RE: DRAINAGE PLAN FOR AN ADDITION TO WALMART STORE #824
(G-19/D4) ENGINEER'S STAMP DATED MAY 23, 1989

GRADING AND DRAINAGE PLAN
WAL-MART STORE # 824 STOCKROOM ADDITION

LA MIRADA SQUARE AS-BUILT GRADING PLAN

RE: DRAINAGE PLAN FOR IMPROVEMENTS TO LA MIRADA SQUARE
(G-19/D4) ENGINEER'S STAMP DATED MAY 18, 1989

STORM SEWER PROFILE

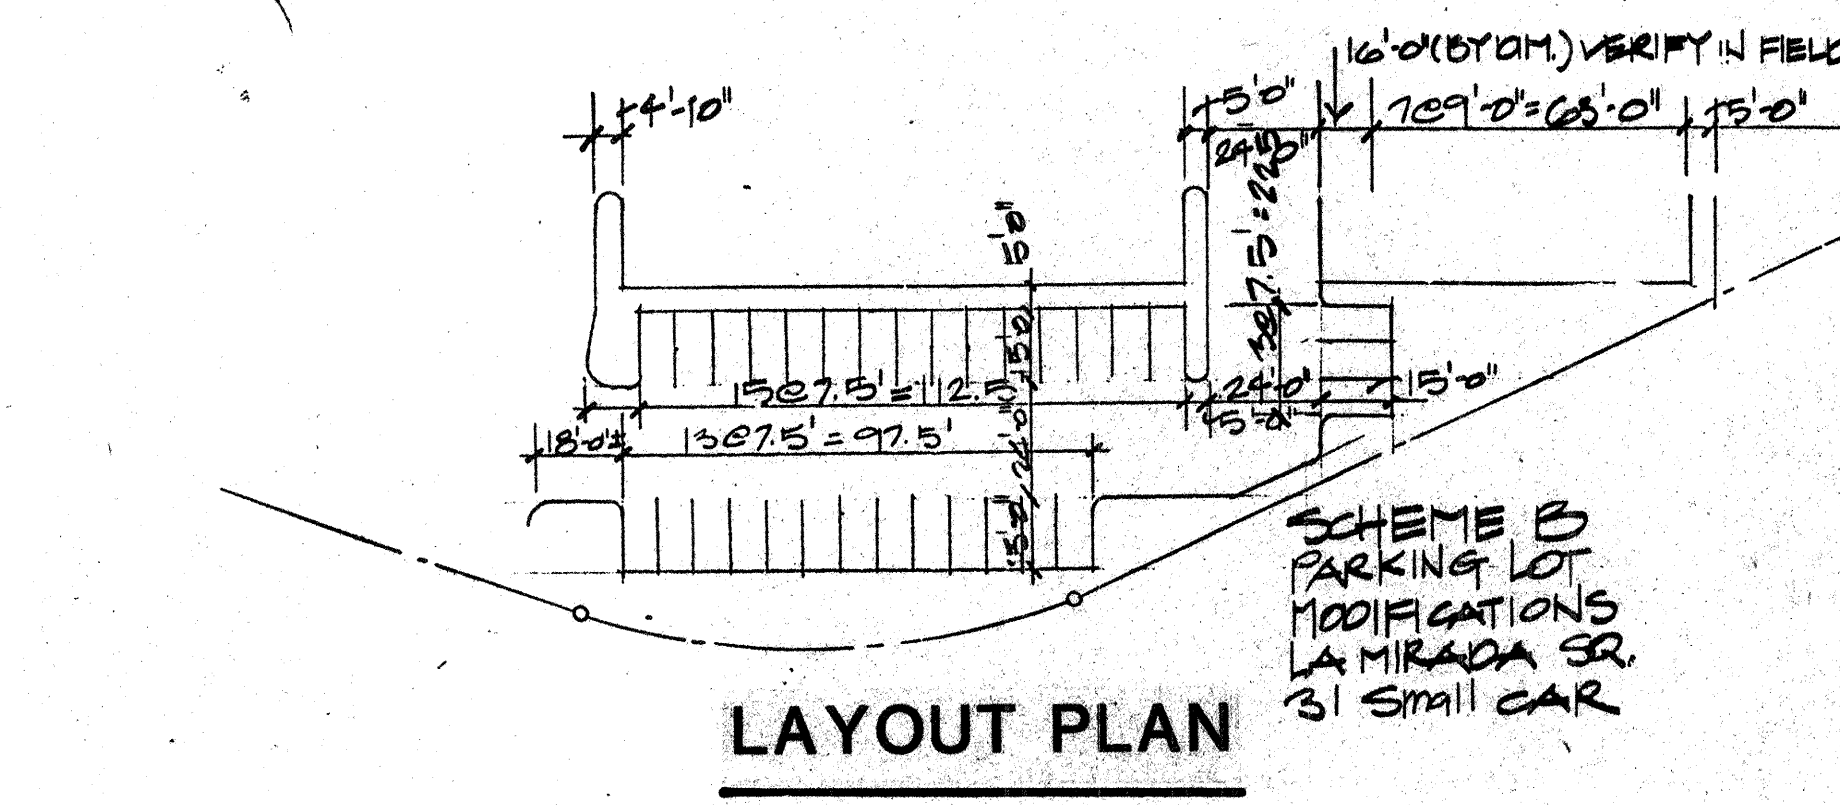
Based on the information provided on your submittal of May 18, 1989, the above referenced plan is approved for Grading/Paving.

Please be advised that the tie-in to the existing storm sewer line must go through work order procedure and be reviewed by D.R.C..
